UNITED STATES PATENT AND TRADEMARK OFFICE

APPLICATION NO.	FILING DATE	FIRST NAMED INVENTOR	ATTORNEY DOCKET NO.	CONFIRMATION NO.
10/066,066	01/31/2002	Robert W. Aukerman	P 1028.11004	2497

Office Action Summary

DETAILED ACTION***Drawings***

U.S. Patent Jan. 23, 2001 Sheet 2 of 8 US 6,176,184 B1

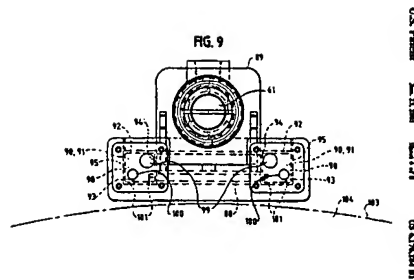
- {claim 1} An ink drying system (column 1, lines 5-9), coupled to a source of pressurized gas (figure 2, references 41, 57),

and comprising a plurality of plenums (figure 9, references 90),

each plenum including an associated plurality of orifices (figure 9, reference 101); a plurality of fluid flow valves for controlling fluid communication between the plenums and the source of pressurized gas (figure 2, reference 42); a controller (figure 2, reference 56; column 3, lines 29-52)

- {claim 2} drying portions provide substantially complete laterally extending coverage of the sheet (figure 2, references 39, 43 W; column 4, lines 63-67) and wherein the drying portion of at least one of the plenums provides a substantially different range of laterally extending coverage of the sheet than at least one other of the plenums (figure 9, references 90)
- {claim 3} at least two of the plenums are spaced substantially apart from one another in a direction of travel of the sheet by a predetermined distance (figure 9, references 90; column 4, lines 42-52) and wherein the drying portions of the plenums are each substantially laterally co-extensive (figure 9, references 90; column 4, lines 63-67; column 5, lines 1-2)
